Wisconsin Department of Transportation

Proposal #05: 1130-65-71, WISC 2026379
Appleton – De Pere
I-41 Mainline, Meade St-Ballard Rd
IH 41
Outagamie County

Letting of July 14, 2026

This is Addendum No. 01, which provides for the following:

Addendum No. 01
ID 1130-65-71
Revised Sheet 275
July 2, 2026

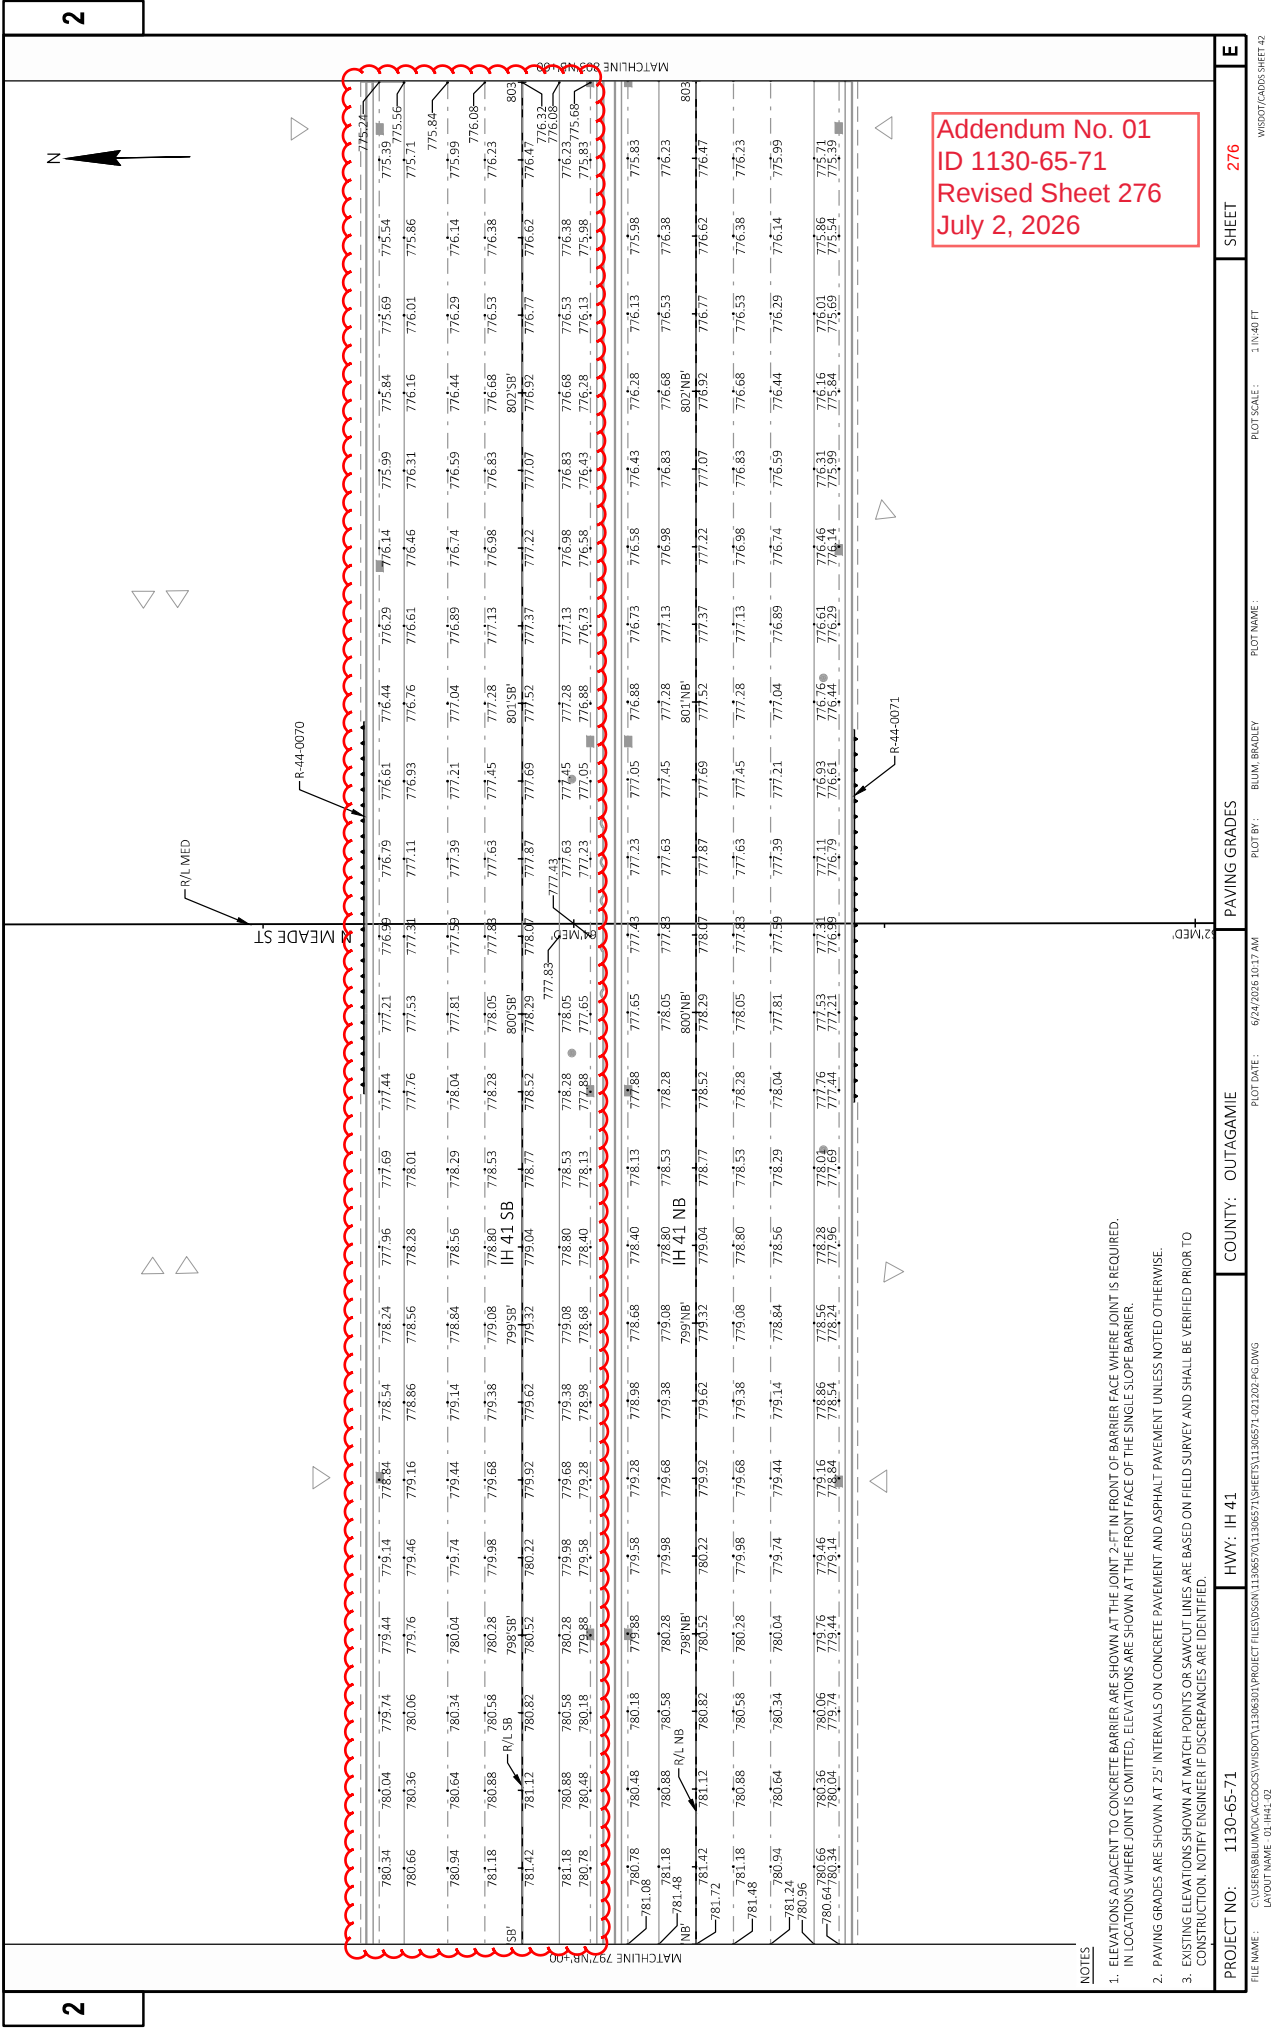
Revised Plan Sheets	
Plan Sheet	Plan Sheet Title (brief description of changes to sheet)
275-285	Added missing paving grades
542	Box Culvert size updated
1390	Miscellaneous Quantities (Earthwork summary updated to include relief trench excavation.)
1424	Pavement Marking MQ update
1436	Miscellaneous Quantities (Added additional quantity for emergency response to traffic impacting temporary concrete barrier wall)
1442	Miscellaneous Quantities (Earthwork summary updated to include relief trench excavation.)
1492	Pavement Marking MQ update

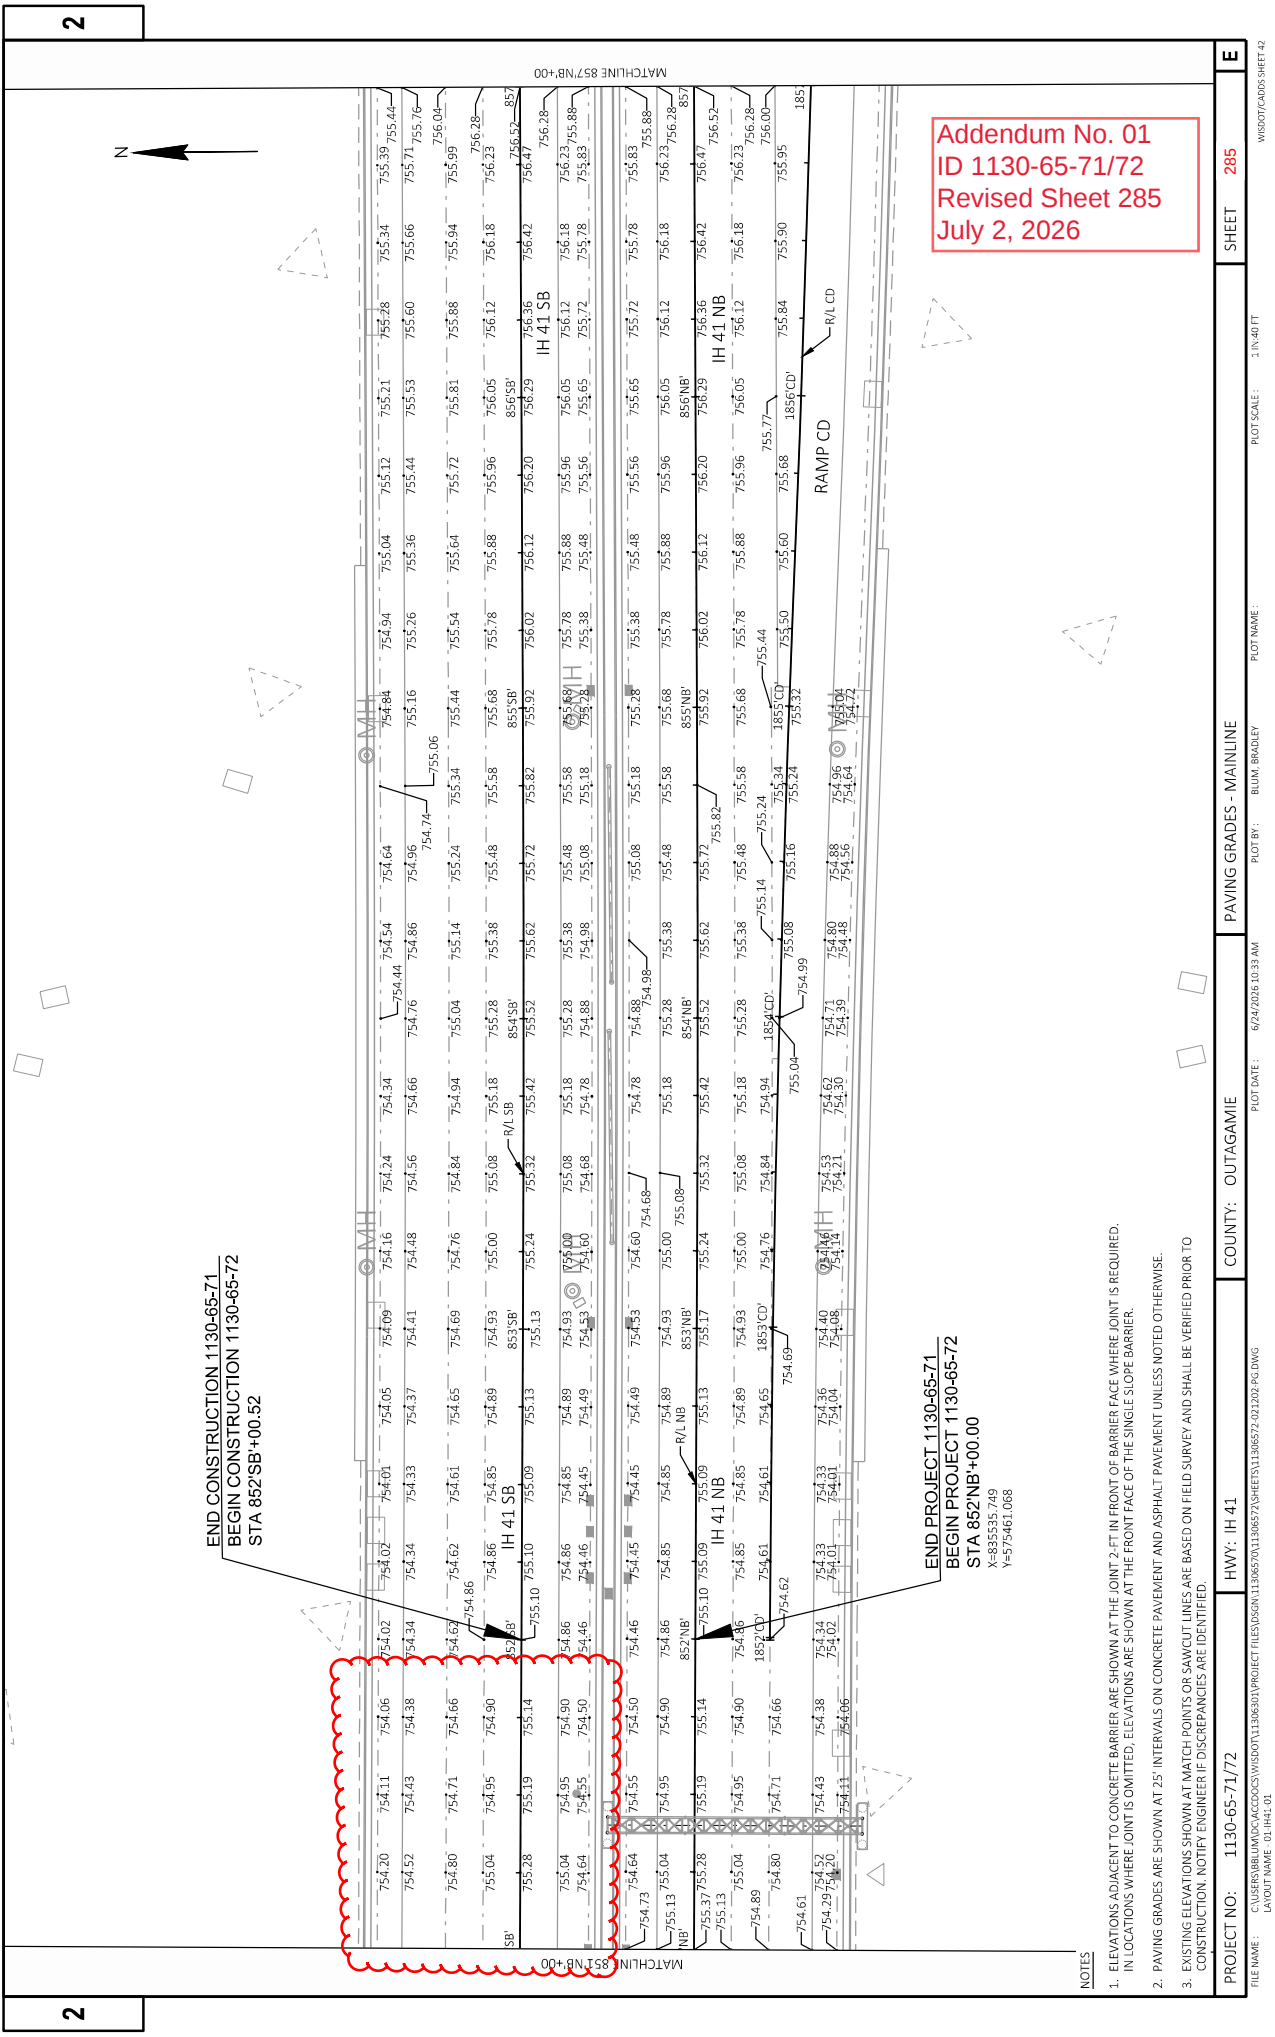
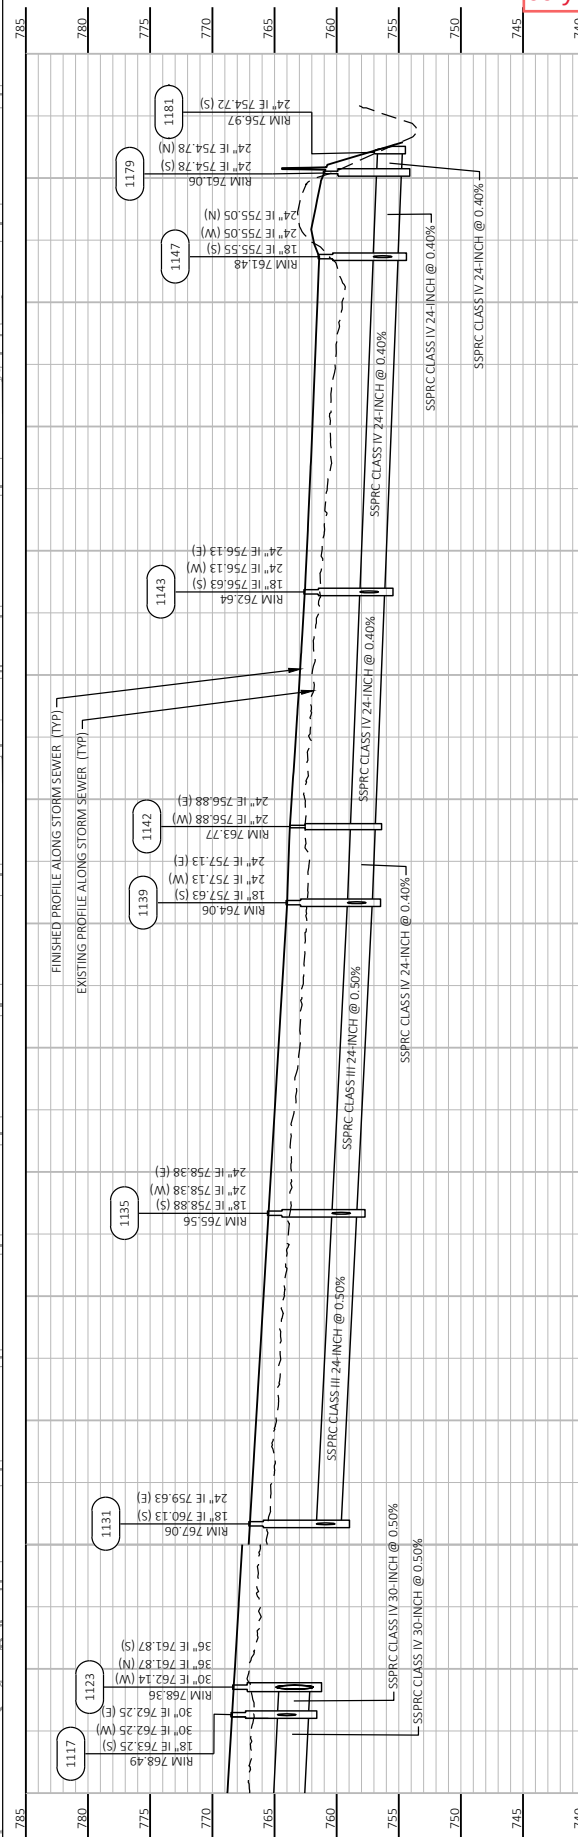
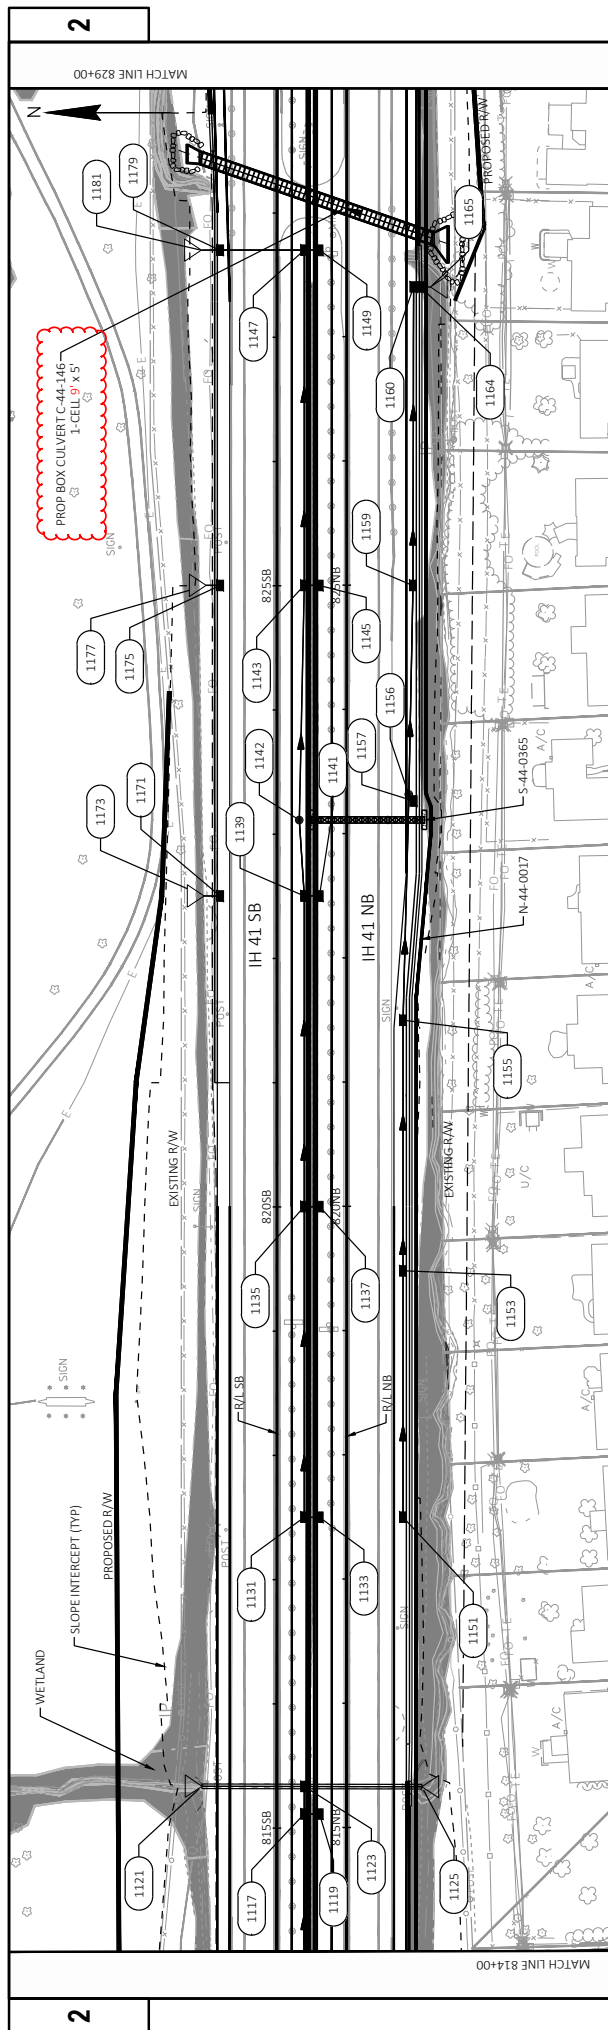
Added Bid Item Quantities					
Bid Item	Item Description	Unit	Proposal Total Prior to Addendum	Quantity Added	Proposal Total After Addendum
646.2025	Marking Line Grooved Black Epoxy 6-Inch	LF	0	3,654	3,654
646.4025	Marking Line Grooved Black Epoxy 10-Inch	LF	0	6,000	6,000
SPV.0090.0900	Precast Concrete Box Culvert, 8 FT x 4FT	LF	0	198	198

Deleted Bid Item Quantities					
Bid Item	Item Description	Unit	Proposal Total Prior to Addendum	Proposal Quantity Change (-)	Proposal Total After Addendum
SPV.0090.0910	Precast Concrete Box Culvert 9 Ft x 5 FT	LF	398	-398	0
